The Use of the Silva-Lambe-Marr Method for Estimating the Annual Probability of Failure of the Tailings Dams at the Copper Mountain Mine, British Columbia, Canada

Steven H. Emerman, Ph.D., Malach Consulting, LLC, 785 N 200 W, Spanish Fork, Utah 84660, USA, Tel: 1-801-921-1228, E-mail: SHEmerman@gmail.com

Report prepared for Confederated Tribes of the Colville Reservation, submitted July 1, 2022

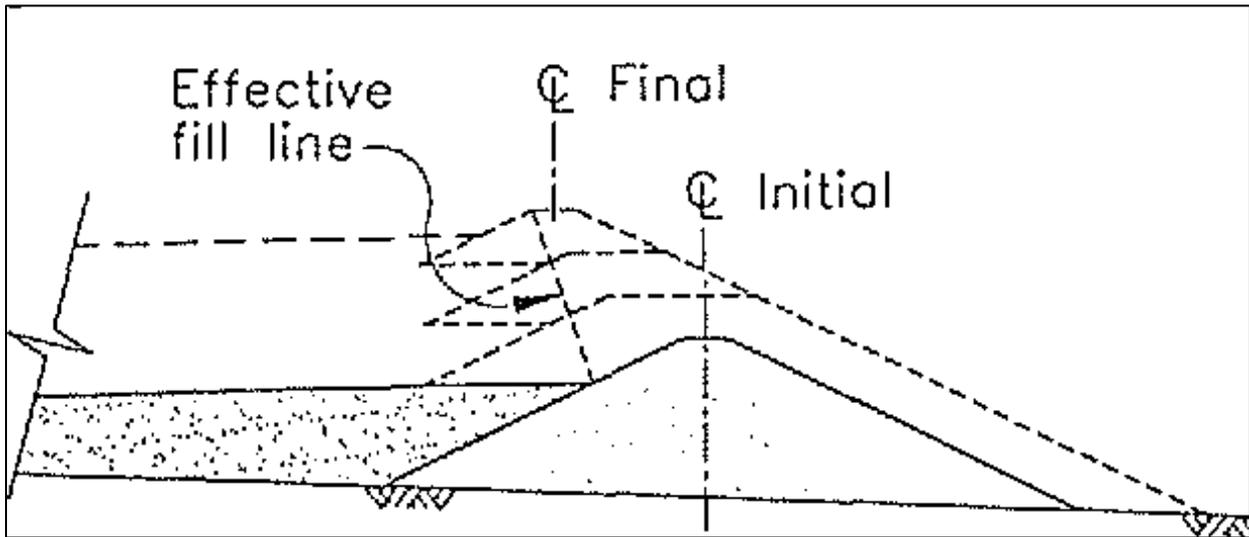
Figure 13. In the modified centerline construction method, the contact between the successive dikes and the uncompacted tailings slopes in an upstream direction (compare with Figs. 12a and 12c). According to TailPro Consulting (2022), “In countries where upstream construction is not permitted (i.e. due to seismic risk), the modified centreline method may also not be permitted due to the concept of partially placing construction material on the existing tailings beach.” *Safety First: Guidelines for Responsible Mine Tailings Management* confirms that “since modified centerline construction still involves constructing a portion of the dam on top of the uncompacted tailings, it must be considered a variant of upstream construction, similarly subject to the cautions and restrictions associated with upstream-type dams presented in this document” and adds that “in some jurisdictions where upstream dams have already been banned, operating companies have used the concept of ‘modified centerline’ to avoid the prohibition. What these operating companies call a modified centerline design must be considered an upstream dam because it still includes construction of the dam on top of uncompacted tailings. Operating companies must correctly identify upstream construction to regulatory agencies” (Morrill et al., 2022). Figure from Haile and Brouwer (1994).

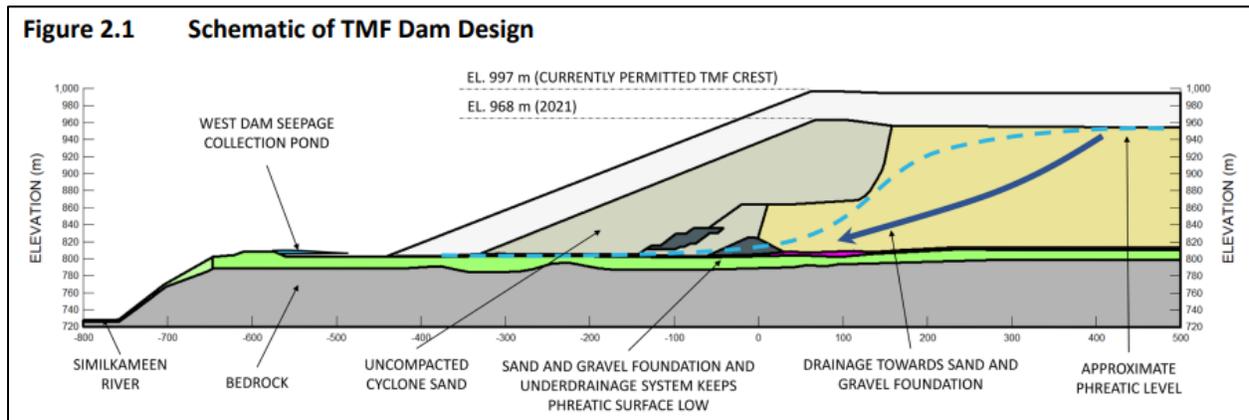
Figure 18. The cross-section of the West Dam clarifies that, despite the use of the term “modified centerline,” the tailings dams at the Copper Mountain mine are constructed using the upstream method, in that the dikes (uncompacted cycloned sand) are constructed on top of the uncompacted, fine-grained tailings (tan color) that they are impounding (compare with Figs. 12a, 13 and 14). The upstream construction method is the cheapest because it requires the least amount of construction material (compare Figs. 12a-c). The method is also the most dangerous because, if the underlying tailings liquefy, the dikes can fail by falling into or sliding over the liquefied tailings even if the dikes temporarily maintain their structural integrity. The upstream construction method is prohibited in Brazil, Chile, Ecuador and Peru. Figure from Klohn Crippen Berger (2022a).

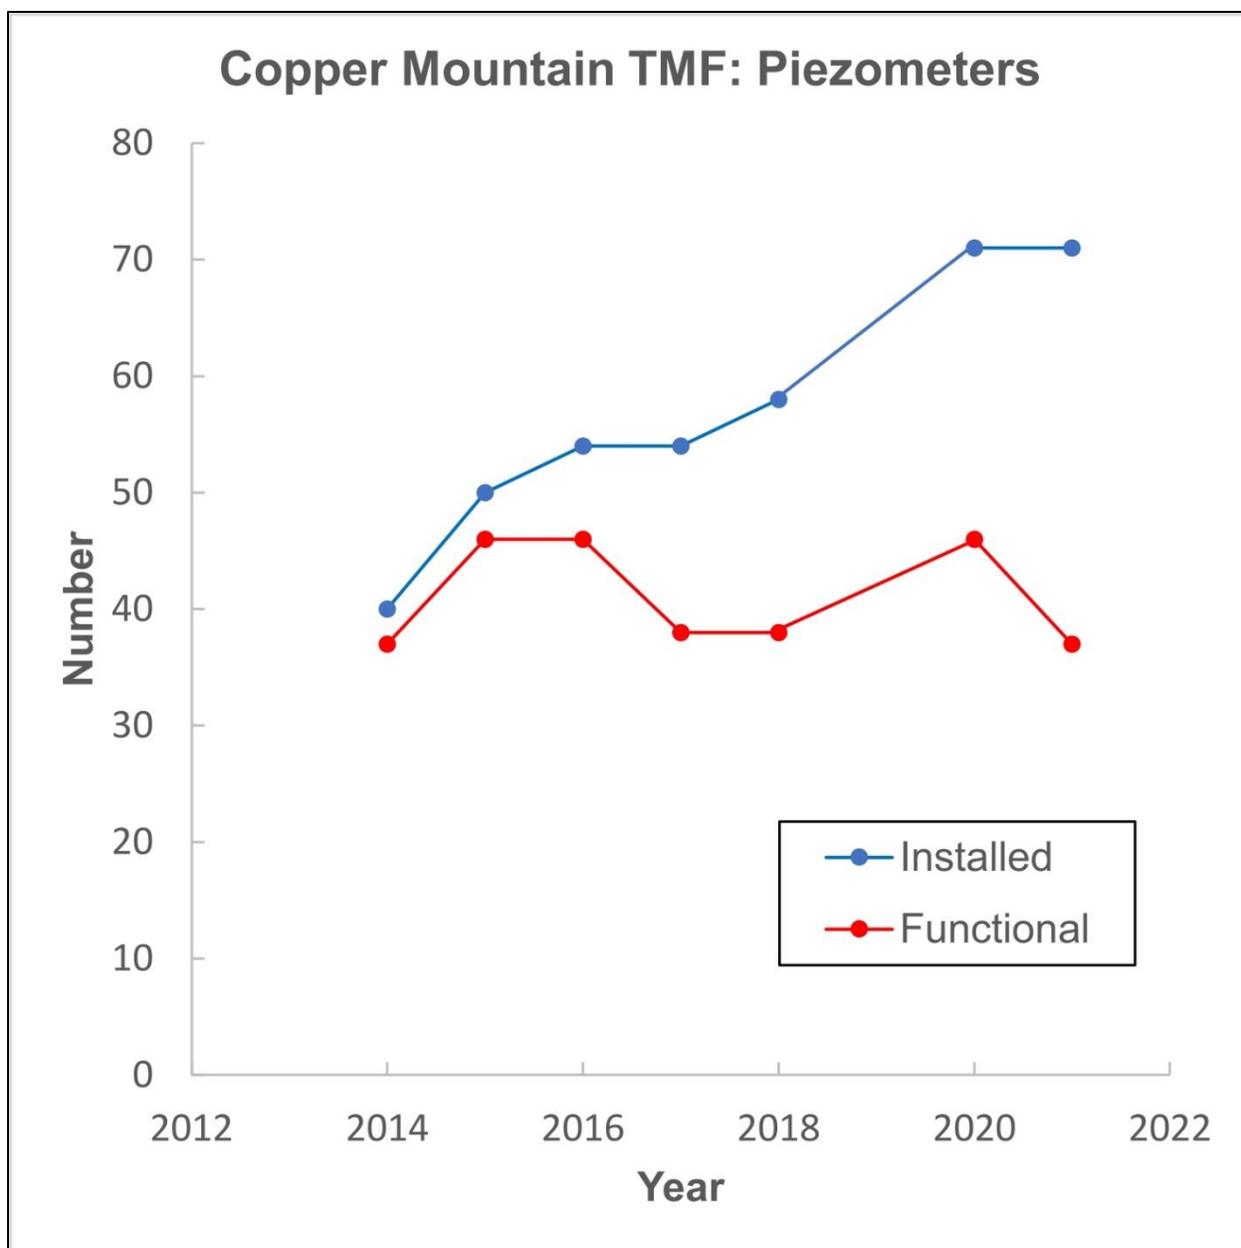
Figure 32. Since 2015 the number of functional piezometers at the Copper Mountain Tailings Management Facility has varied between 37 and 46, and was at an all-time low at the end of 2021. The 2021 Dam Safety Review critiqued the lack of piezometers and the resultant inability to adequately define the phreatic surface (water table) for calculation of the factor of safety (see Figs. 27a-b). The category Best for Level of Engineering in the area Operation and Monitoring would require “No malfunctions” and “Continuous maintenance by trained crews,” implying that annual dam safety inspections should not report non-functional instrumentation (see Table 1e). The category Above Average would require “no uncorrected malfunctions,” implying that non-functional instruments should be repaired or replaced. However, a characteristic of the category Average is “no field measurements,” implying the absence of any piezometers. On the above basis, the category for Level of Engineering in the area of Operation and Monitoring was chosen as Average to Above Average (see Table 1e). The choice is also consistent with the lack of a “complete performance program including comparison between predicted and measured performance (e.g., pore pressure, strength, deformations),” which would be required by the category Best. Finally, the choice is consistent with the existence of both periodic and annual inspections by qualified engineers that is required by the categories Above Average and Average, respectively. Data from AMEC (2014, 2016a) and Kloth Crippen Berger (2017b, 2018, 2019, 2021, 2022a).

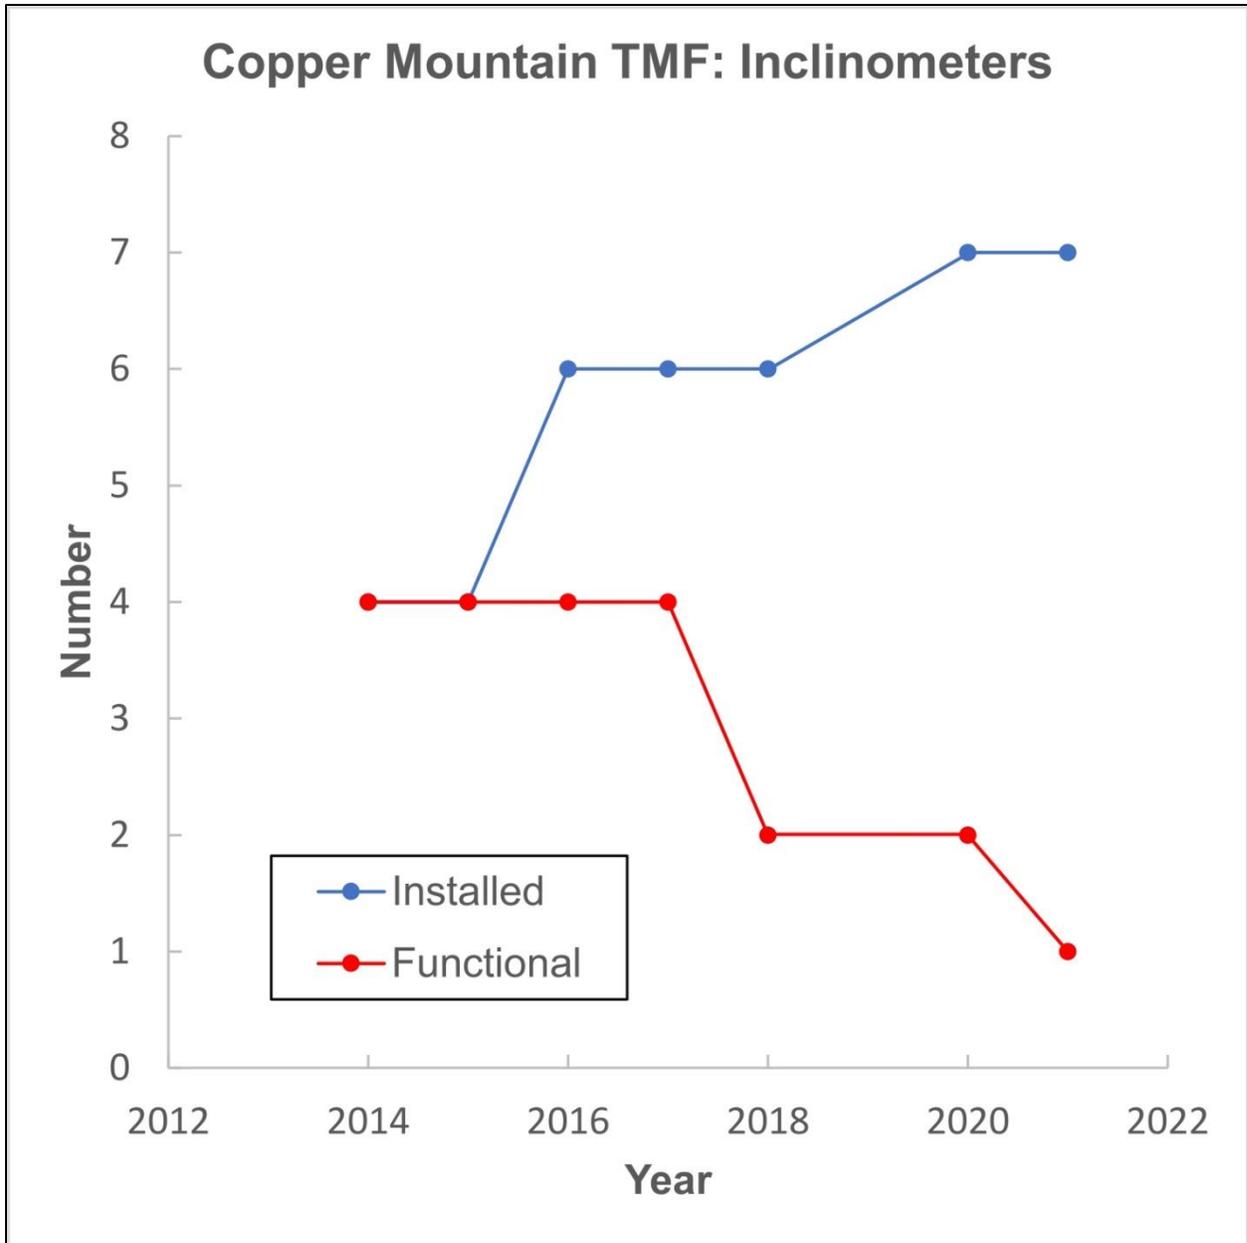
Figure 33. Since 2015 the number of functional inclinometers at the Copper Mountain Tailings Management Facility has steadily dropped until only one functional inclinometer remained at the end of 2021. The category Best for Level of Engineering in the area Operation and Monitoring would require “No malfunctions” and “Continuous maintenance by trained crews,” implying that annual dam safety inspections should not report non-functional instrumentation (see Table 1e). The category Above Average would require “no uncorrected malfunctions,” implying that non-functional instruments should be repaired or replaced. However, a characteristic of the category Average is “no field measurements,” implying the absence of any piezometers. On the above basis, the category for Level of Engineering in the area of Operation and Monitoring was chosen as Average to Above Average (see Table 1e). The choice is also consistent with the lack of a “complete performance program including comparison between predicted and measured performance (e.g., pore pressure, strength, deformations),” which would be required by the category Best. Finally, the choice is consistent with the existence of both periodic and annual inspections by qualified engineers that is required by the categories Above Average and Average, respectively. Data from AMEC (2014, 2016a) and Klohn Crippen Berger (2017b, 2018, 2019, 2021, 2022a).

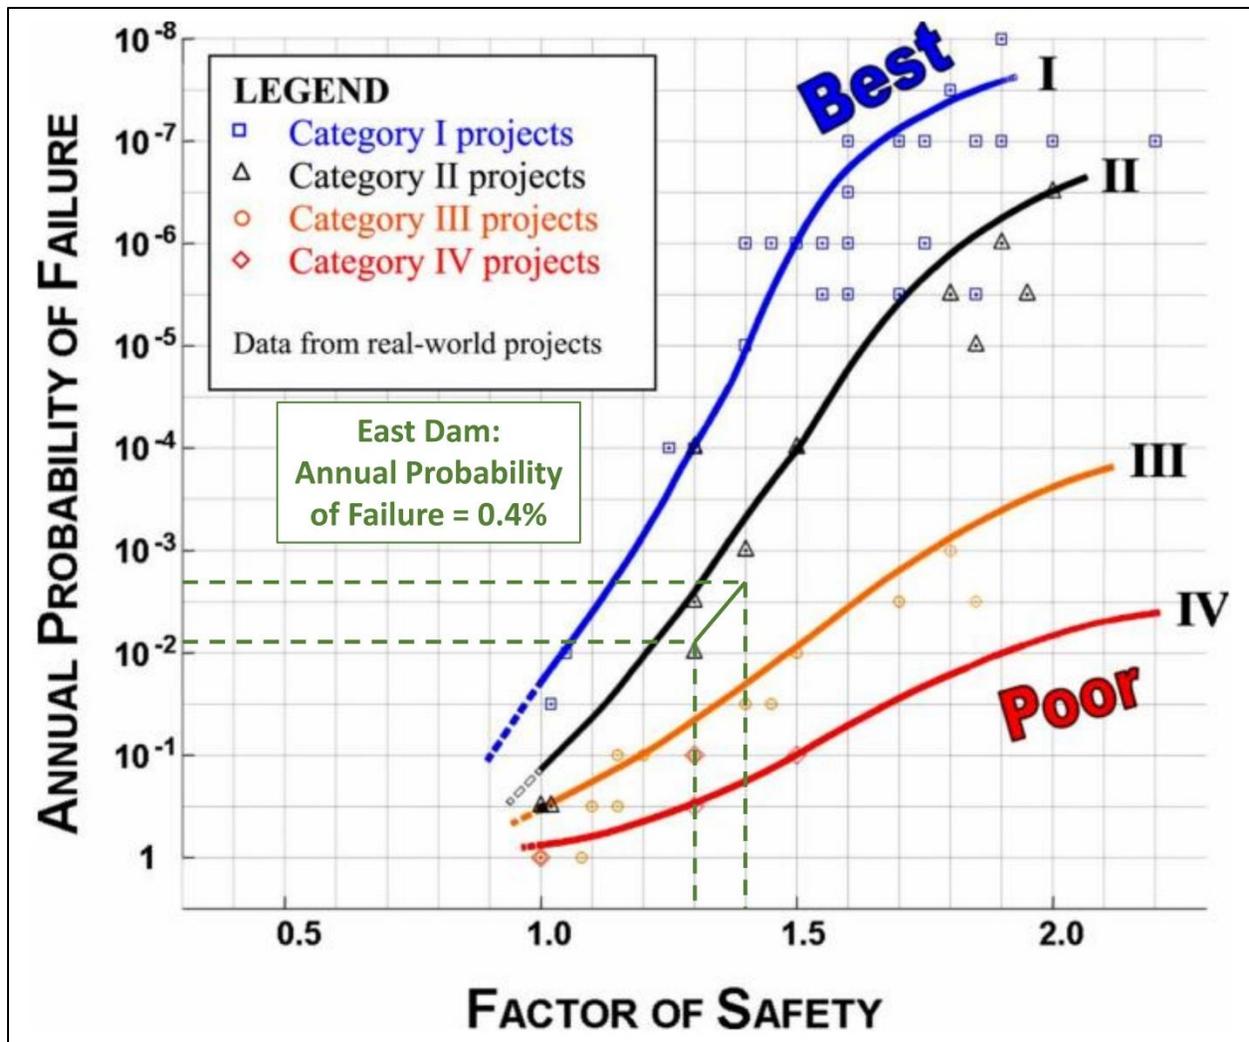
Figure 34a. Based upon calculated factors of safety of $FS = 1.3$ and $FS = 1.4$ (see Fig. 26a) and an overall Level of Engineering of 2.4 (where Above Average = 2 and Average = 3) (see Tables 1a-e), the annual probability of failure of the East Dam was estimated in the range 0.2-0.8% with a best estimate of 0.4%. Based upon the best estimate for the annual probability of failure of the West Dam as 0.05% (see Fig. 34b), the best estimate for the annual probability of failure of the Copper Mountain Tailings Management Facility is 0.45%. Taking into consideration the amount of judgment required in the calculation of the Level of Engineering, the annual probability of failure should be regarded as the range 0.1-1% (1 in 1000 to 1 in 100). Figure modified from Silva et al. (2008).

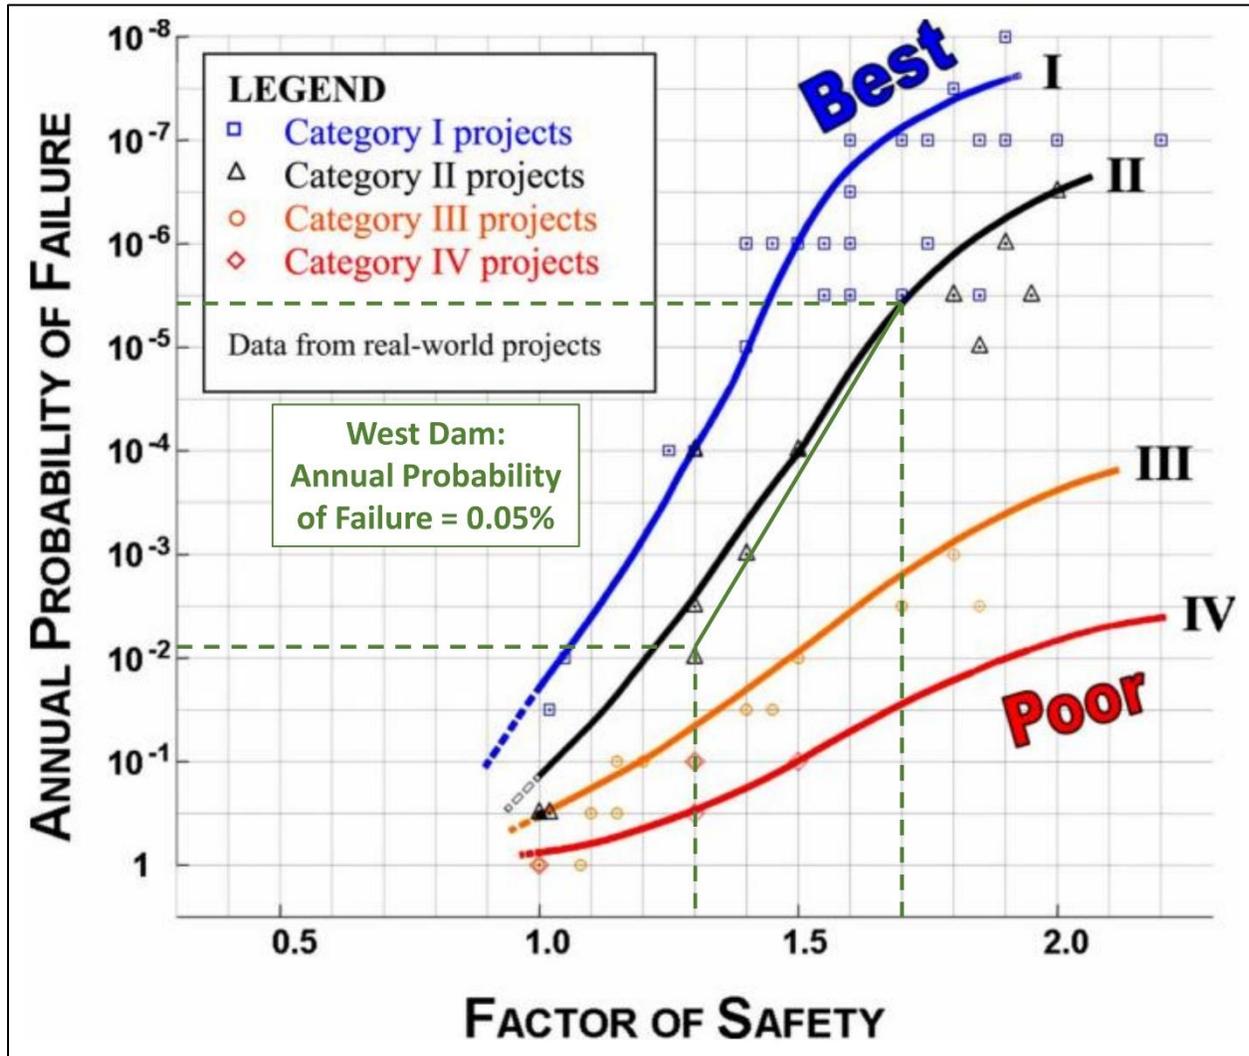
Figure 34b. Based upon calculated factors of safety of FS = 1.3 and FS = 1.7 (see Fig. 26b) and an overall Level of Engineering of 2.4 (where Above Average = 2 and Average = 3) (see Tables 1a-e), the annual probability of failure of the West Dam was estimated in the range 0.004-0.8% with a best estimate of 0.05%. Based upon the best estimate for the annual probability of failure of the East Dam as 0.4% (see Fig. 34a), the best estimate for the annual probability of failure of the Copper Mountain Tailings Management Facility is 0.45%. Taking into consideration the amount of judgment required in the calculation of the Level of Engineering, the annual probability of failure should be regarded as the range 0.1-1% (1 in 1000 to 1 in 100). Figure modified from Silva et al. (2008).
